REVIEW OF
CHALET RIGI DEVELOPMENT -
LOT 3, MUNDARING WEIR ROAD, PIESSE BROOK

30 April 2020

Review of Waste Water Disposal Proposed for the Chalet Rigi Upgrade – Landform Research

SCALE: As Shown
DATE: 29 January 2020
Dwg No. 1 of 8

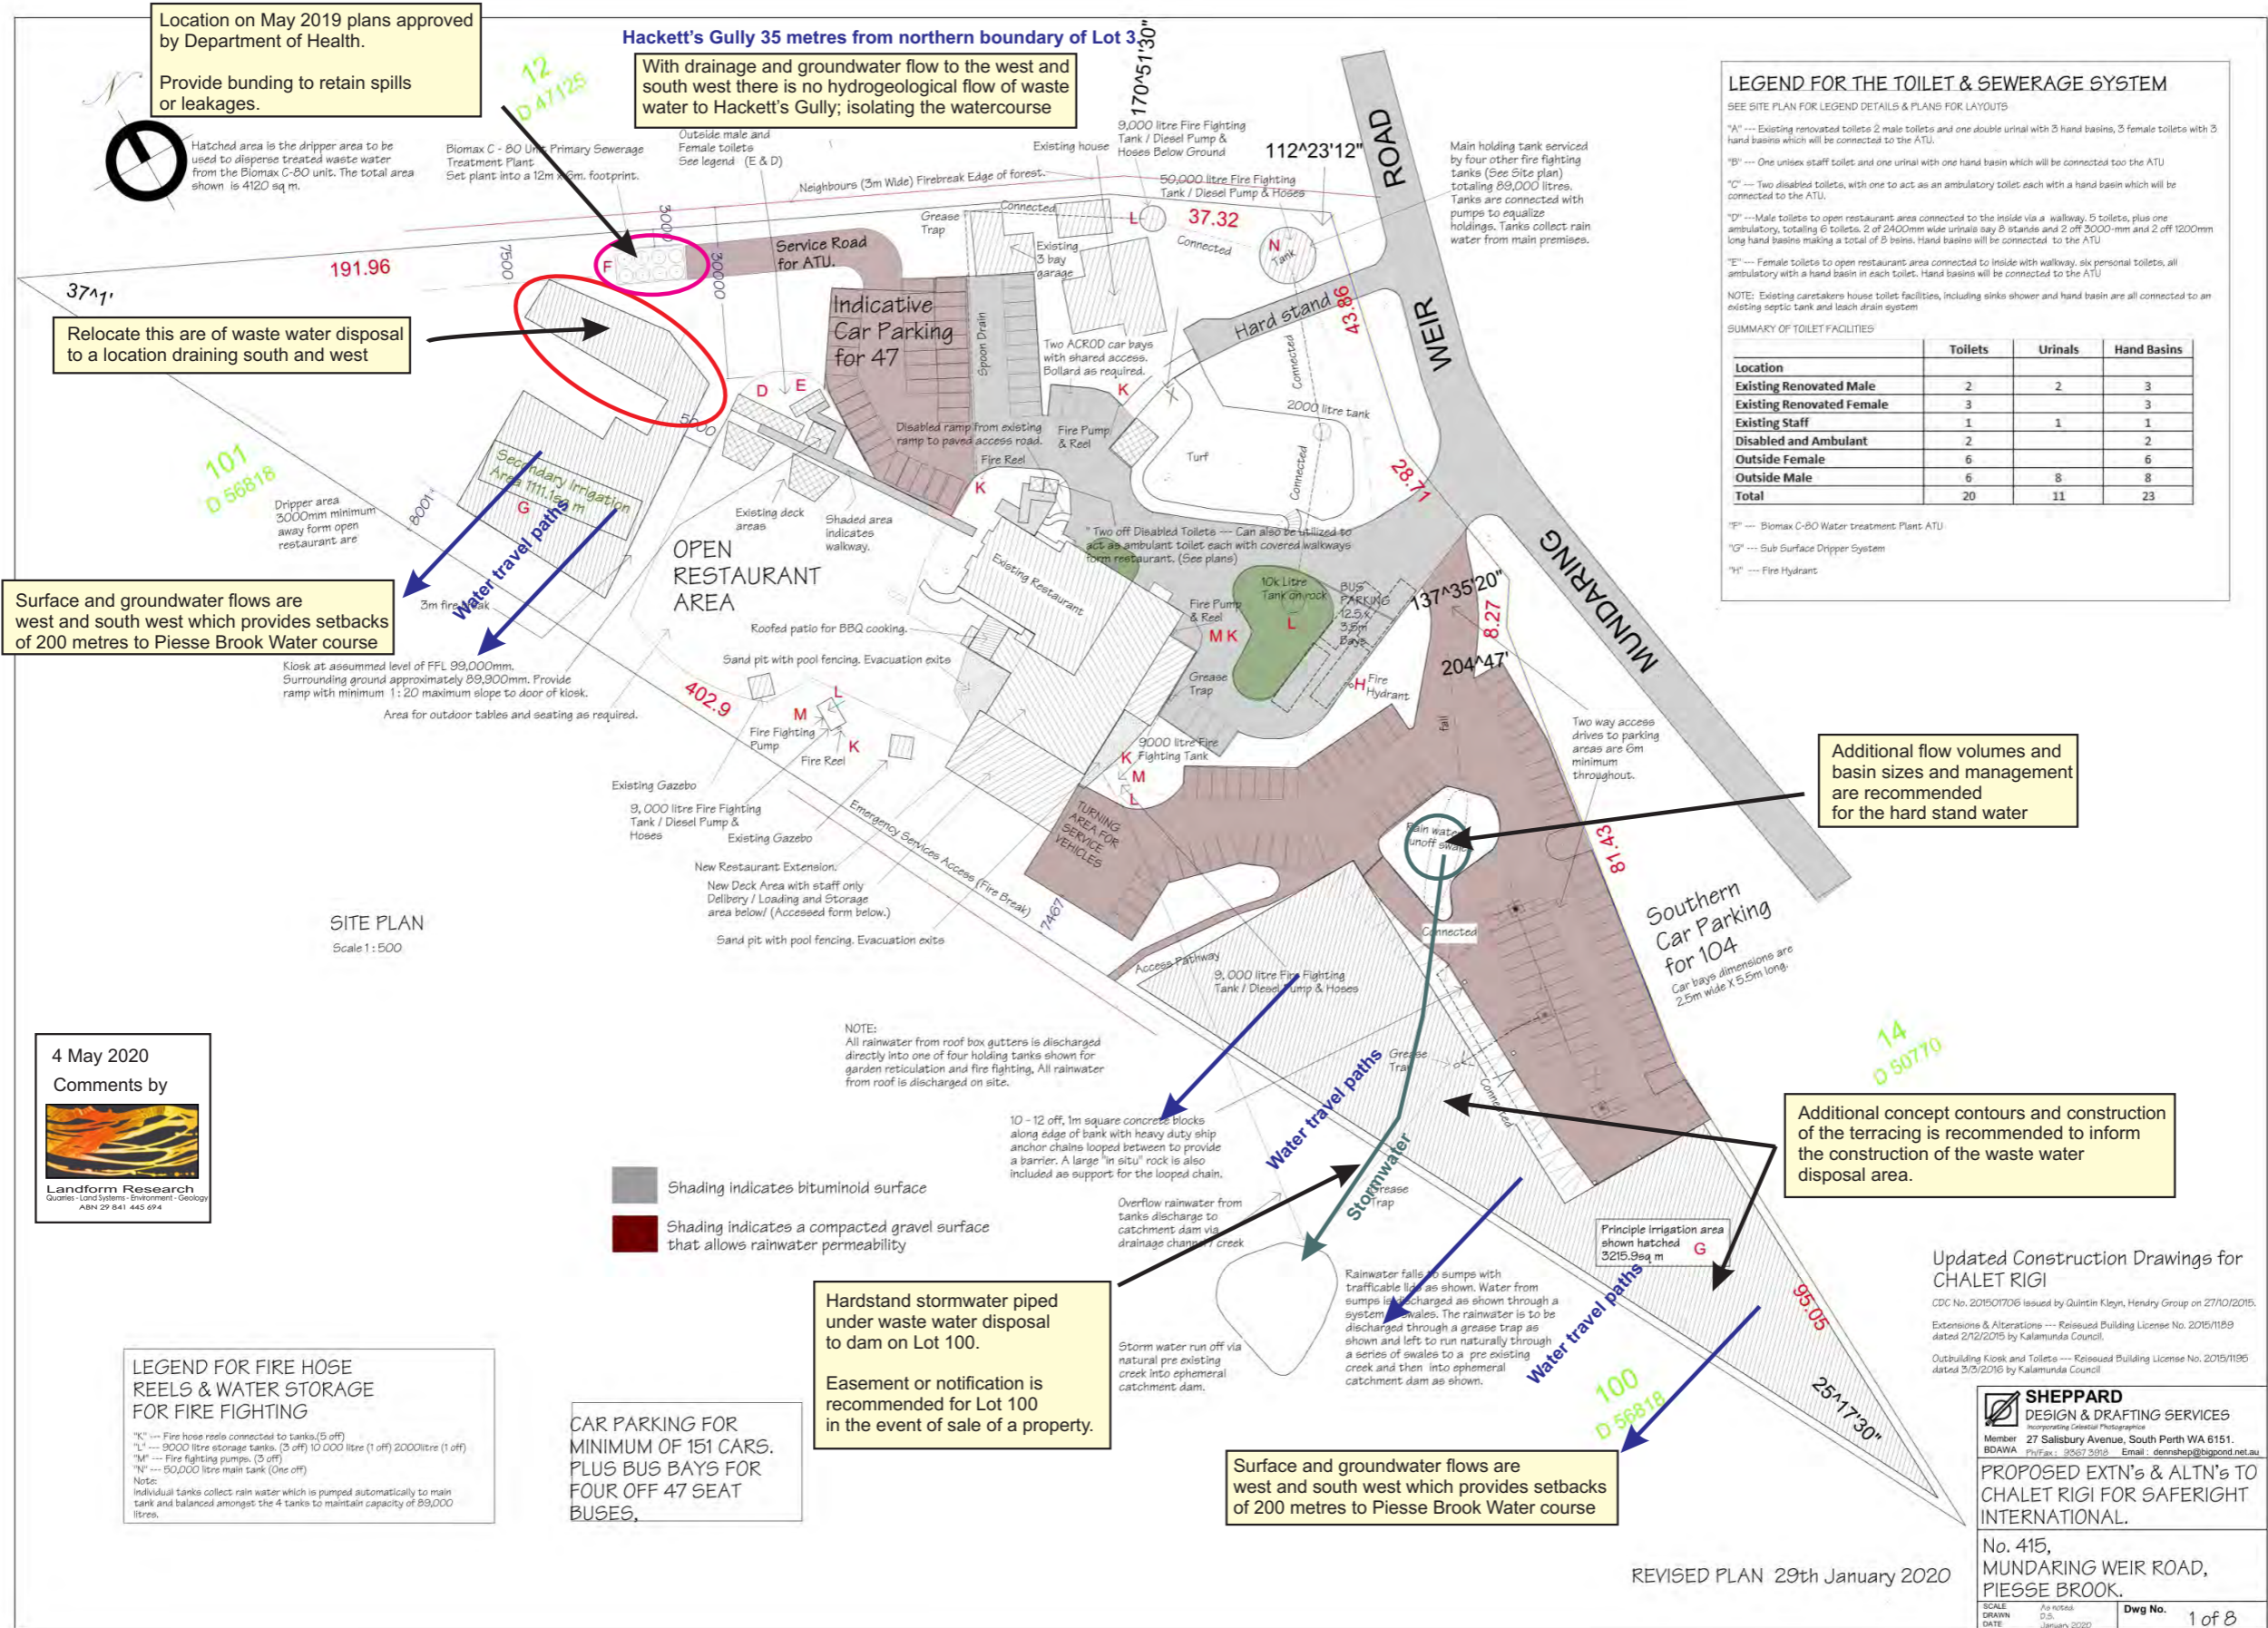
Further brief documentation of the stormwater management to support Evergreen Consultancy WA Pty Ltd Figure 1 of 8, which is the site plan, would be beneficial, and assist construction.

Requirement - Management	Source of Requirement - Management	Current Proposal Compliance	Reference in Evergreen December 2019	Comments – by Landform Research	Landform Research Recommendations - if required
Stormwater from car parking						
18	Waste water separated from stormwater	Advice DWER Advice of 26 February 2020		Water Management Plan Dec 2019. Water Management Plan Dec 2019. Section 9.3, 9.4 Site Plan 1 of 8.	Waste water is to be separated from stormwater from the car park and other areas. That is proposed in the December 2019 Management Plan, but some more detail is recommended with respect to stormwater management, the size of the basins and overflows. The stormwater is proposed to be collected in a central area and then piped under the waste water disposal area through an impermeable pipe system to a dam on the adjoining land to the west (owned by the proponent).	Ensure that all stormwater is separated from waste water and that neither is able to impact on each system. There does not appear to be a detailed description of the stormwater management apart from Site Plan 1 - 8

Location on May 2019 plans approved by Department of Health.
Provide bunding to retain spills or leakages.

Hackett's Gully 35 metres from northern boundary of Lot 3
With drainage and groundwater flow to the west and south west there is no hydrogeological flow of waste water to Hackett's Gully; isolating the watercourse

Relocate this area of waste water disposal to a location draining south and west

Surface and groundwater flows are west and south west which provides setbacks of 200 metres to Piesse Brook Water course

Additional flow volumes and basin sizes and management are recommended for the hard stand water

Additional concept contours and construction of the terracing is recommended to inform the construction of the waste water disposal area.

Hardstand stormwater piped under waste water disposal to dam on Lot 100.
Easement or notification is recommended for Lot 100 in the event of sale of a property.

Surface and groundwater flows are west and south west which provides setbacks of 200 metres to Piesse Brook Water course
